SEMMMS A6 to Manchester Airport Relief Road

Aecom: WCML Crossing Option Comparison
(Over v Under)

1007/6.19/108

June 2012

Drawing No.	Revision
1007/3D/DF5/A6-MA/GA/657

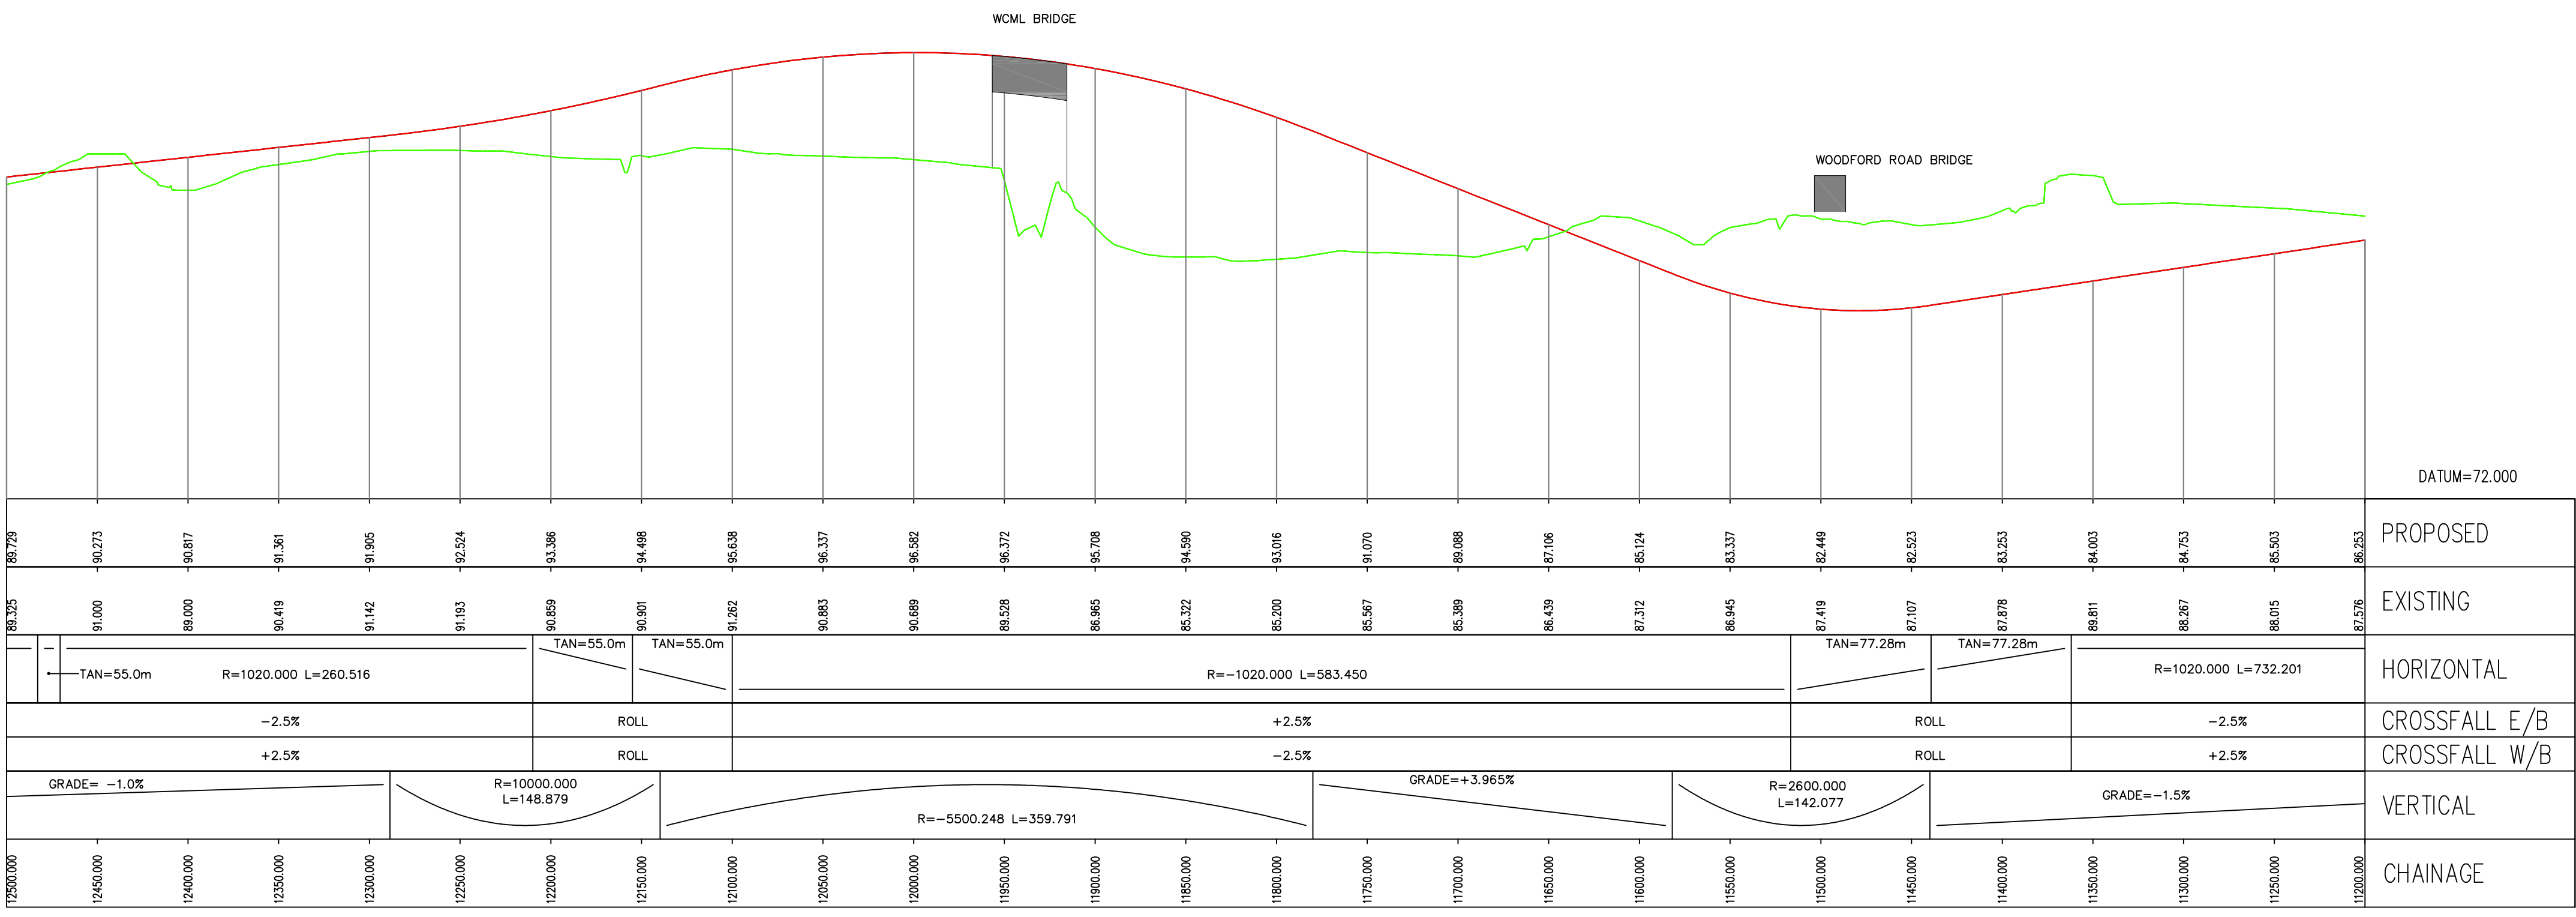
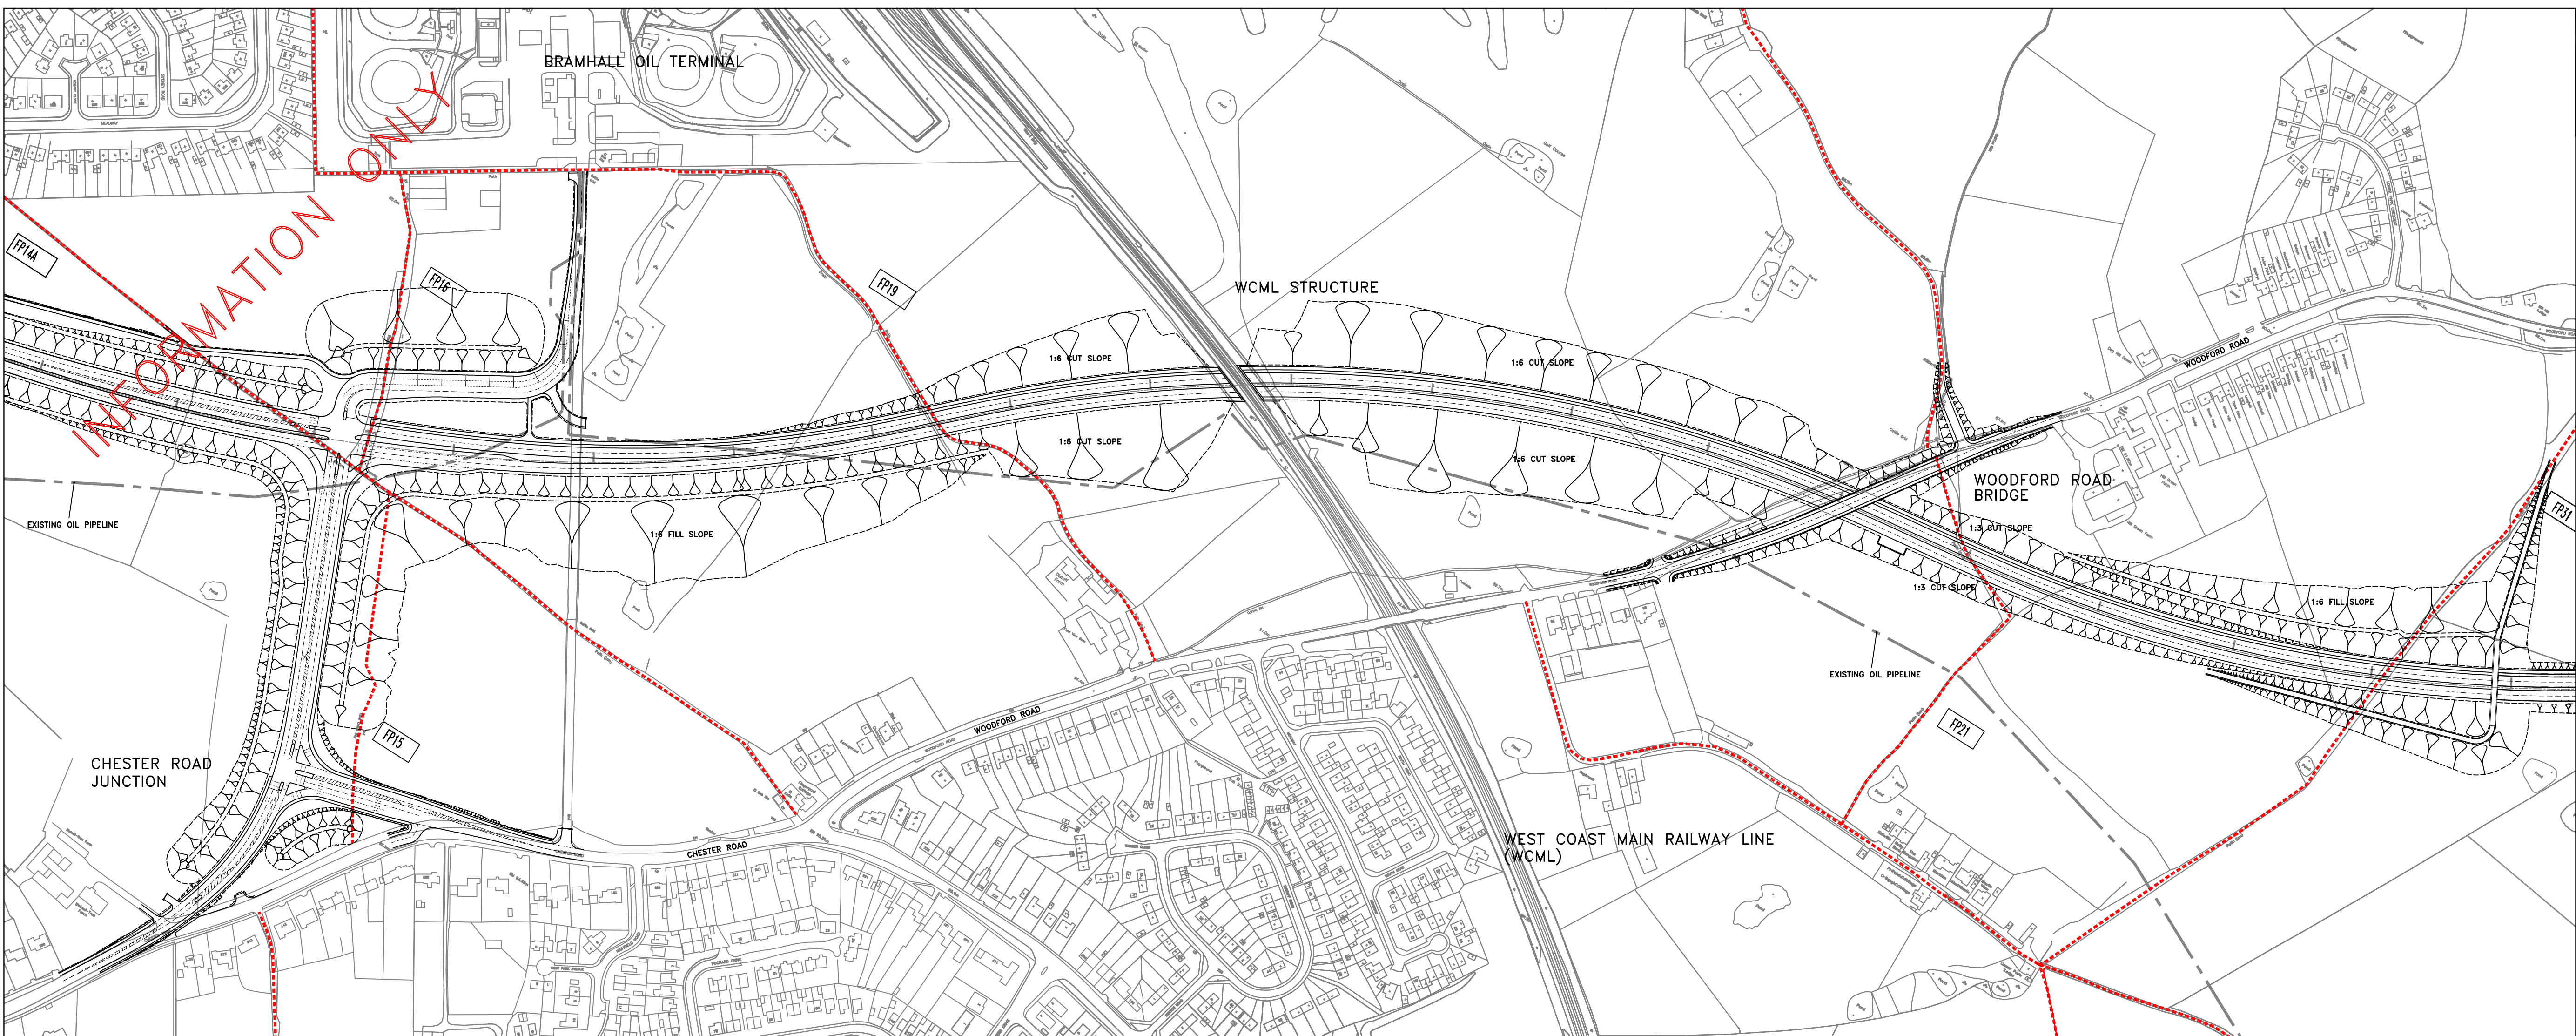
Vertically, Design Freeze 5 shows a road alignment which supplies a vertical clearance of 7m, as shown on the General Arrangement drawing. This should provide more than Network Rail's requirement for a minimum of 5.8m clearance from rail to soffit level and adequate clearance to the existing overhead line equipment. SMBC commissioned ND Oliver to carry out a topographic survey at this location and the road alignment reflects the updated knowledge of the relevant OHLE levels plus agreed Network Rail minimum clearance.

Location of the crossing and longitudinal highway profile for a road over rail crossing at Design Freeze 5 are shown on Stockport MBC drawing No. 1007/3D/DF5/A6-MA/GA/657 and for rail over road on drawing No. 1007/3D/DF5/A6-MA/GA/615, both included in Appendix A of the Report. A copy of the recent topographic survey with the Relief Road superimposed is also included in Appendix C of this Report.

The bridge design shown on supplied drawing 1007/3D/DF5/A6-MA/B008/708 is considered appropriate, but consideration should be given to reducing the vertical alignment shown at Design Freeze 5 as there appears to be more clearance over the rail than is necessary.

Drawn SP	Engineer SP	Checked NH	Approved MPR
Date 01/03/12	Date 01/03/12	Date 01/03/12	Date 01/03/12
Size A1	PLAN 1:2500 - SECTION HZ 1:2500, VT 1:250		
SCG No.	Filename S:\Projects\SEMMMS Major Information\ 6.0 Highways\6.3 Geometry and Survey		
Drawing No. 1007/3D/DF5/A6-MA/GA/615	Revision

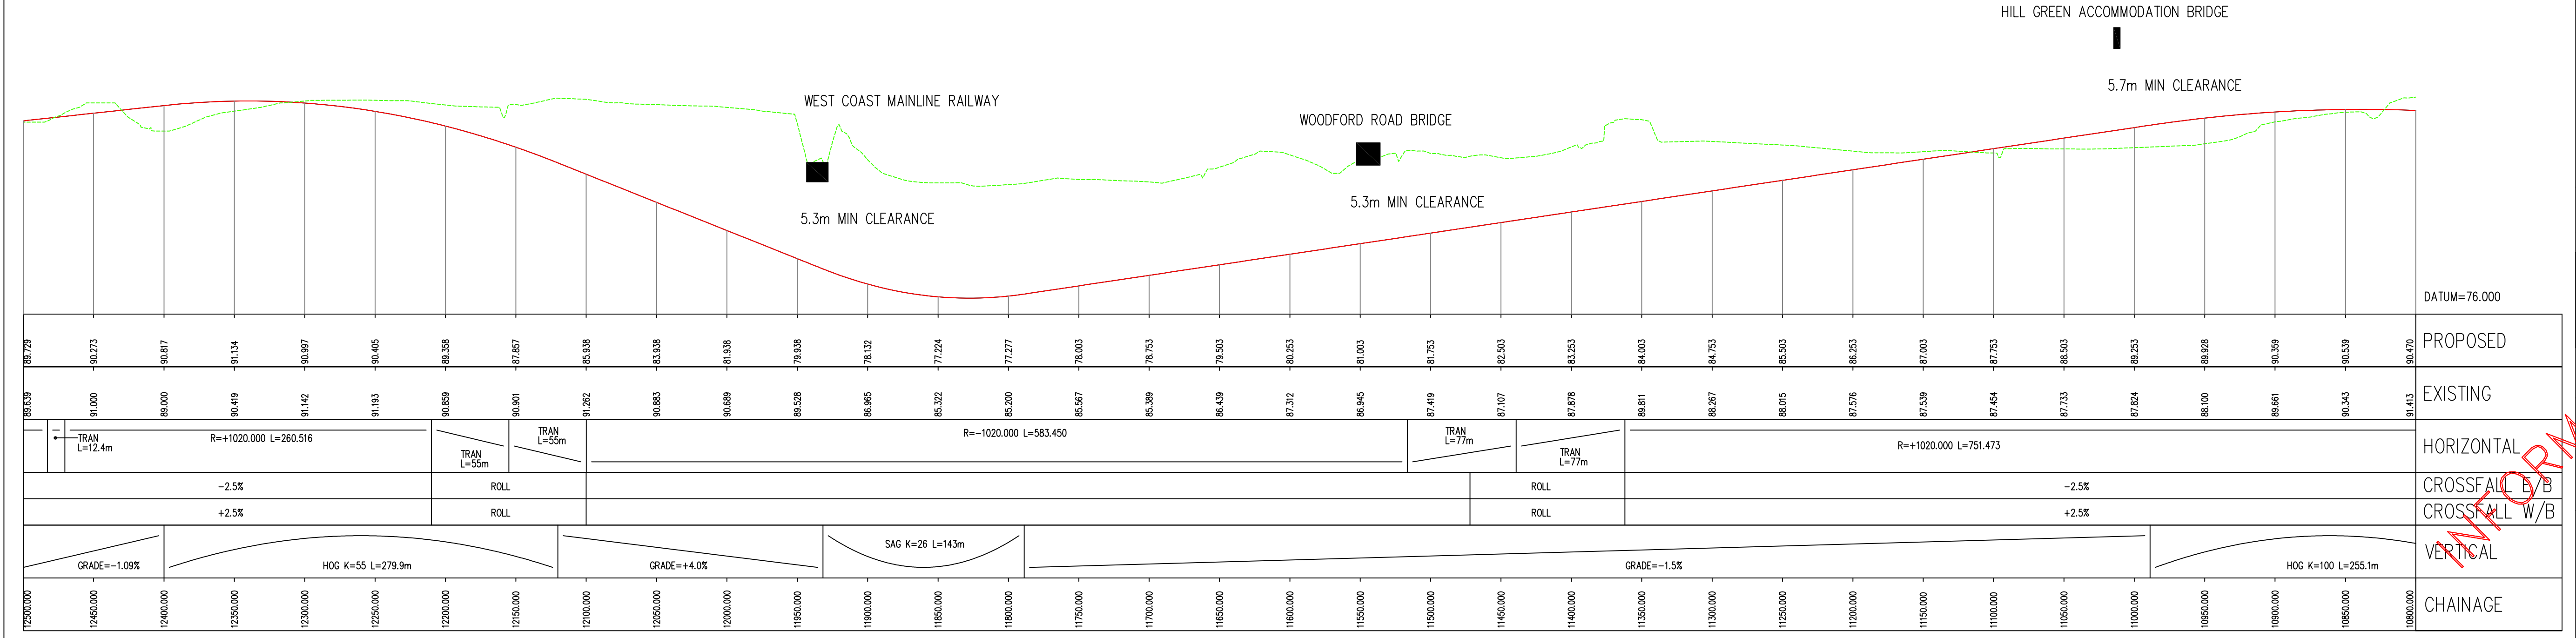
For the road under rail bridge, the vertical clearances are being discussed between the SEMMMS design team, Network Rail and URS. Design Freeze 5 has a road level at sufficient height to accommodate a currently assumed superstructure depth of 1.4m. If this was to change, the highway alignment will be amended to suit.

The option to take the Relief Road beneath the West Coast Main Line will put the route in deep cut on the approaches. No structural proposals have been forwarded by Stockport MBC at the time of writing this document other than the statement that an allowance has been made for a 1.4m deep superstructure, and therefore assumptions herein are purely speculative. The option to take the Relief Road above the West Coast Main Line would also require relatively extensive approach works, meaning the two footprints are comparable.
